July 07, 2022

This Addendum to the Invitation for Bid (IFB) serves to notify all interested bidders of clarifications and or changes to IFB No. P22002, and becomes part of this IFB. Proposers are required to acknowledge receipt of this addendum in their bid. If not acknowledged, Proposers' bid may be considered "non-responsive."

Elderly Development - Fresno Housing Authority  
 2415 5th St  
 Sanger, CA 93657

WEDBWOOD COMMONS  
KIT. REHAB DETAIL

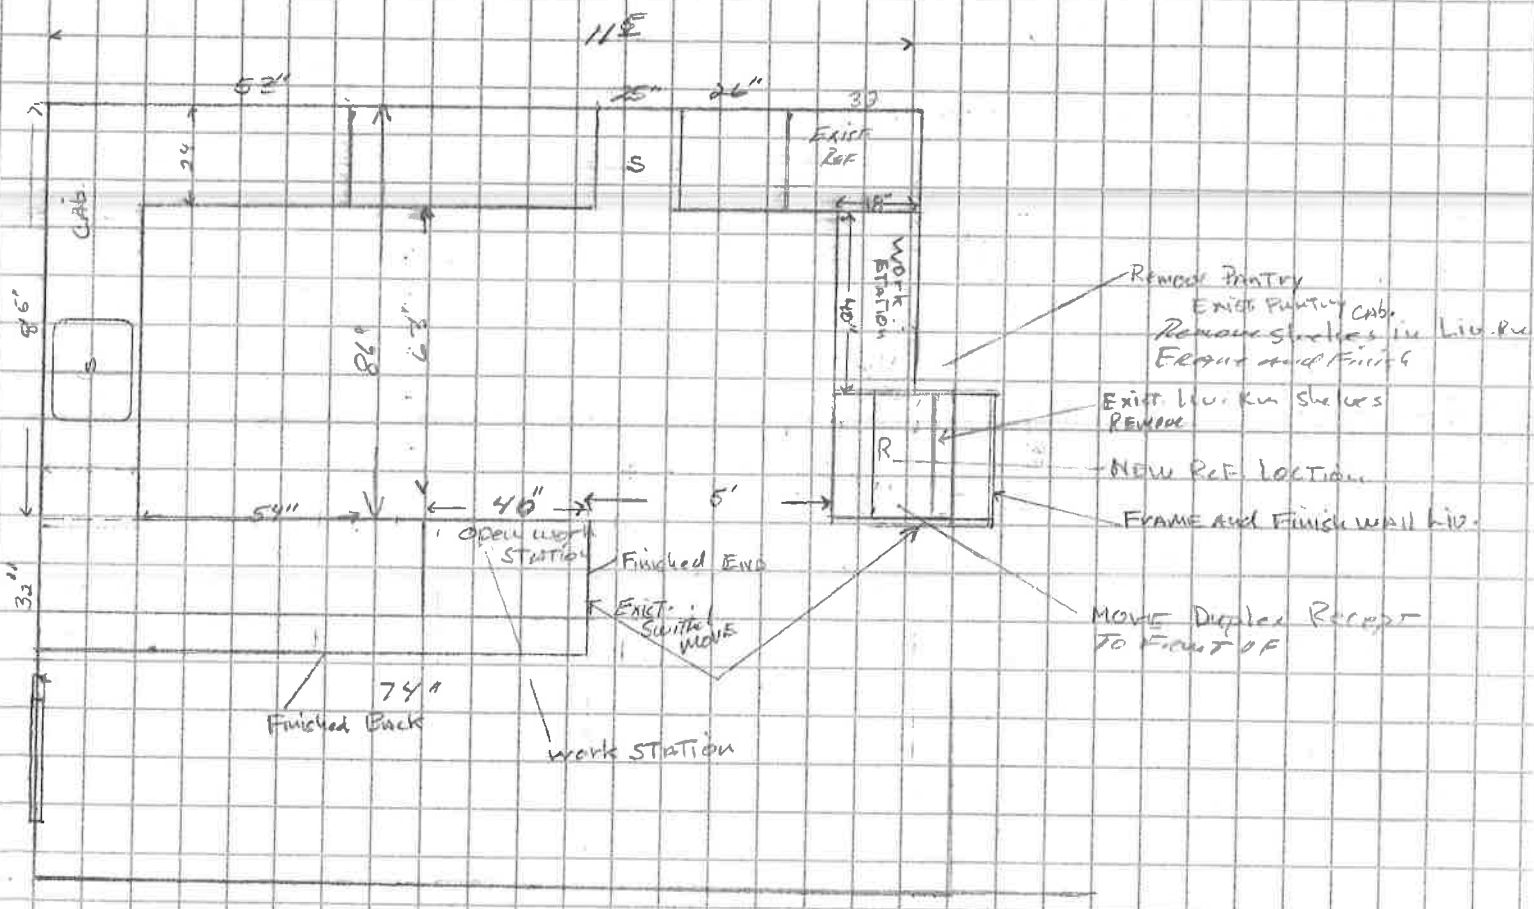
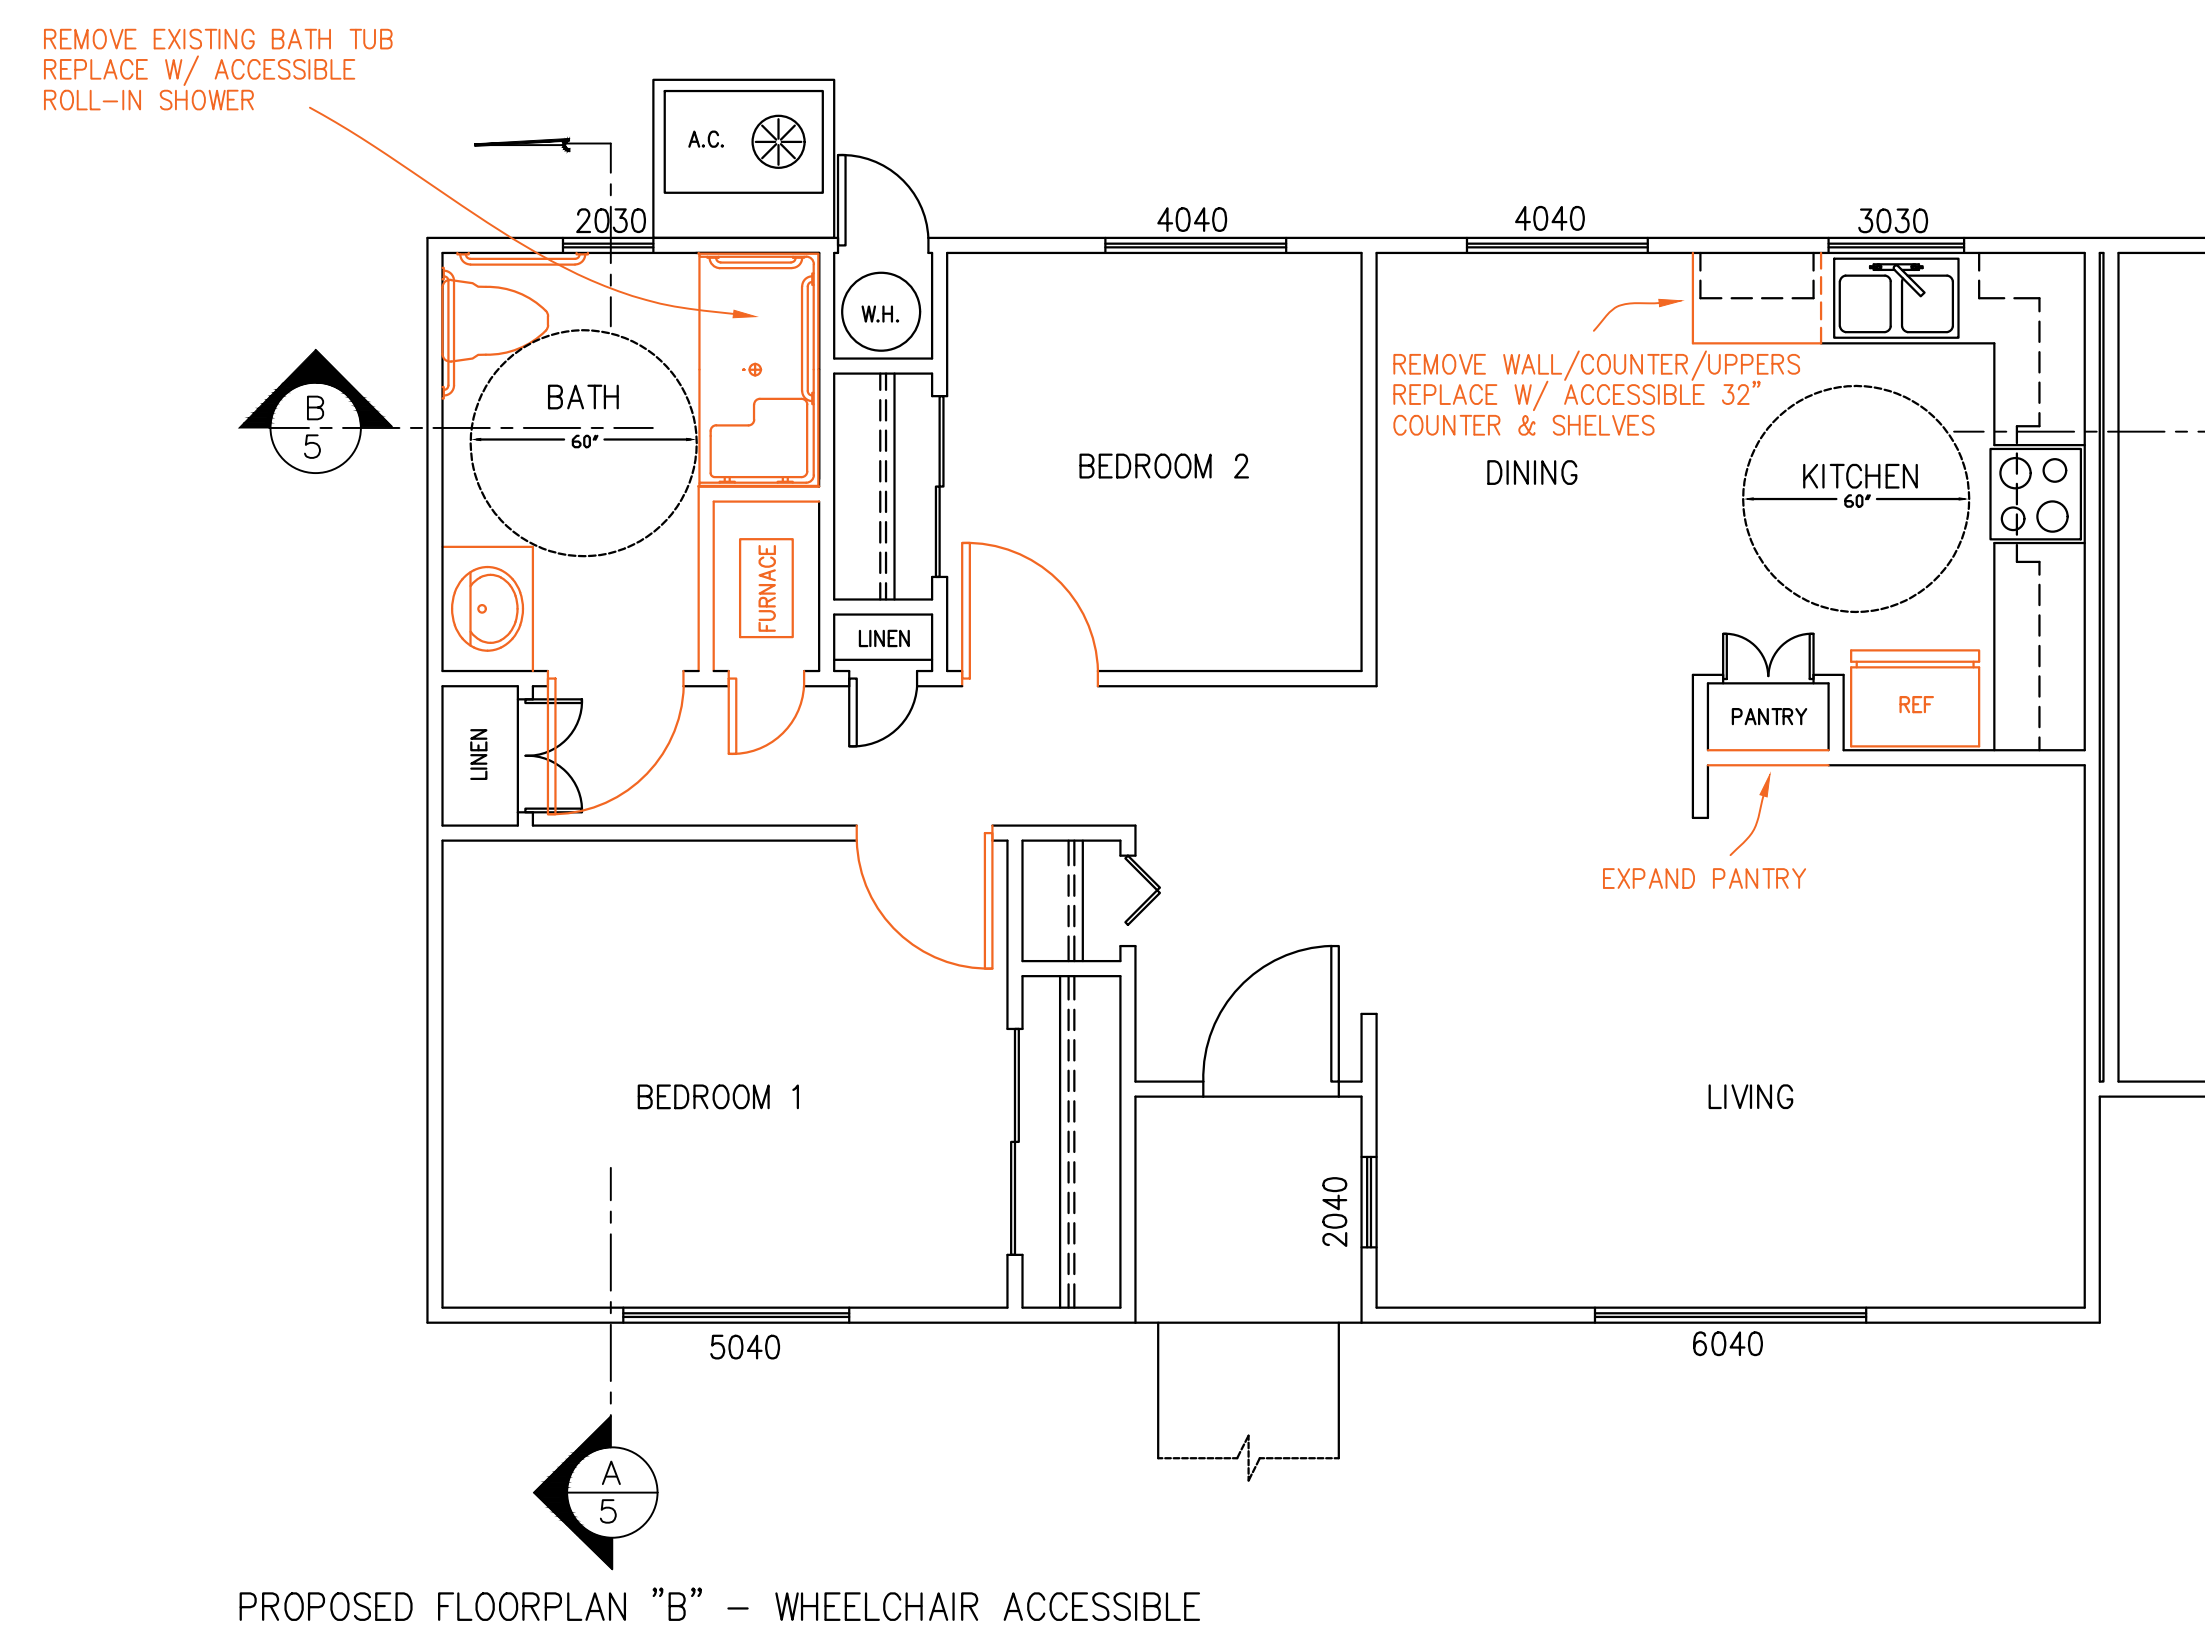
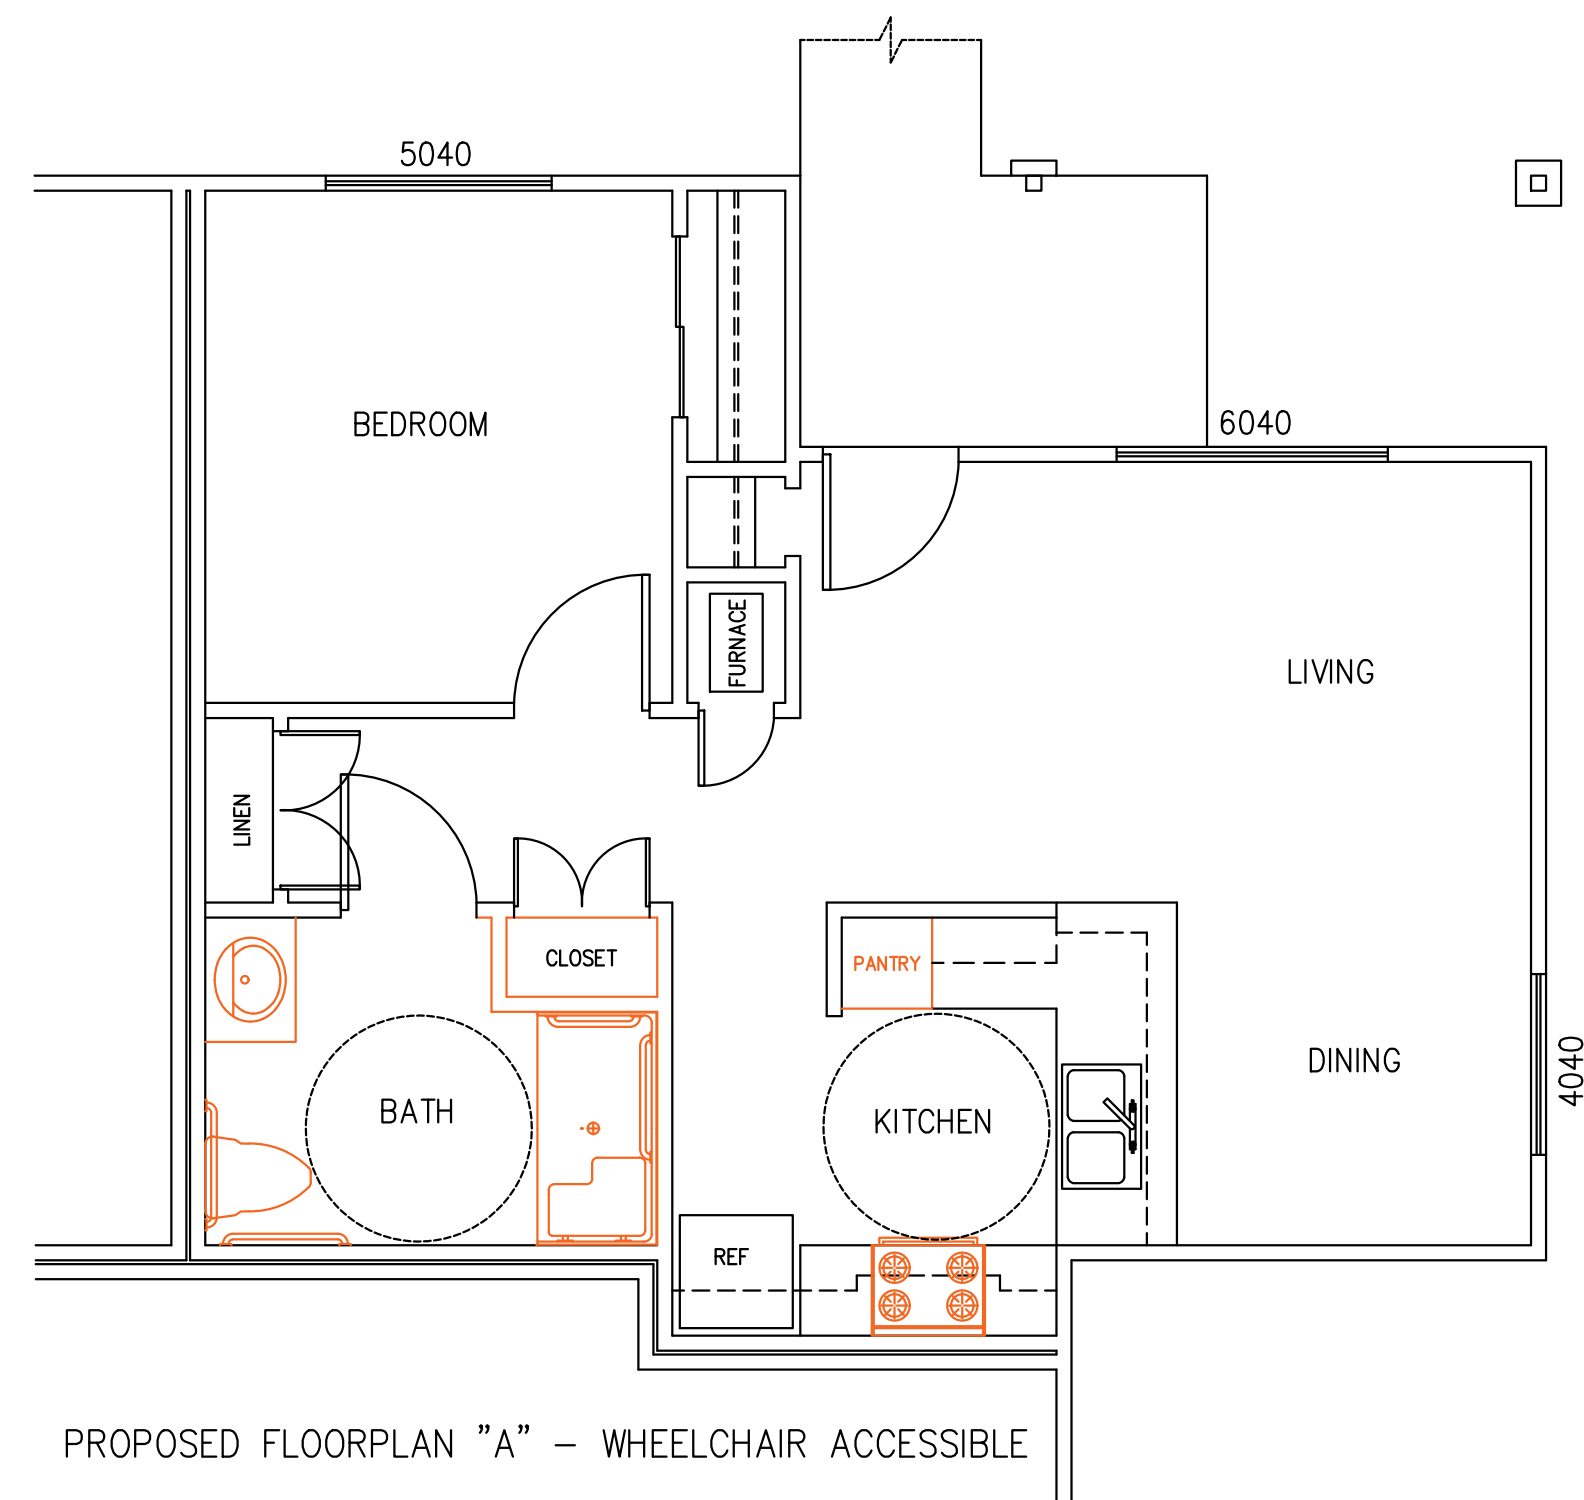
- REMOVE PANTRY
- EXIST. PANTRY CAB.
- REMOVE SHELVES IN LIB. REFRIG. and FINISH
- EXIST. LIB. REFRIG. SHELVES REMOVE
- NEW RCF LOCATION
- FRAME and FINISH WALL L12
- MOME Duplex RECEPT TO FRONT OF

- Replace kitchen cabinets that separate the kitchen and the dining room. Replace all kitchen cabinets upper and lower, except the upper cabinets between kitchen and dining room.

- Install new lower cabinets between the kitchen and dining room .5ft from the lower cabinets on the east wall where the stove is located.
  - Maintain 5ft clearance between the cabinets and bull nose between the cabinets as referenced above.

- Remove the existing pantry cabinets, trim, walls and living room. Shelves as needed for the installation of the existing refrigerator.
- Move/cut and frame walls to accommodate the existing refrigerator.

- Frame and finish walls as needed in living room and refrigerator cavity.
- Relocate duplex receptacle towards the front of the refrigerator wall for accessibility.

- Install new duplex receptacle on the new cabinet wall facing the dining room.
- Install switches for the range hood and light in the front of the new cabinet meeting ADA requirements.

- Relocate the light switches from the kitchen wall being removed to the refrigerator wall facing the living area to the west as close to the front of the refrigerator cavity wall.
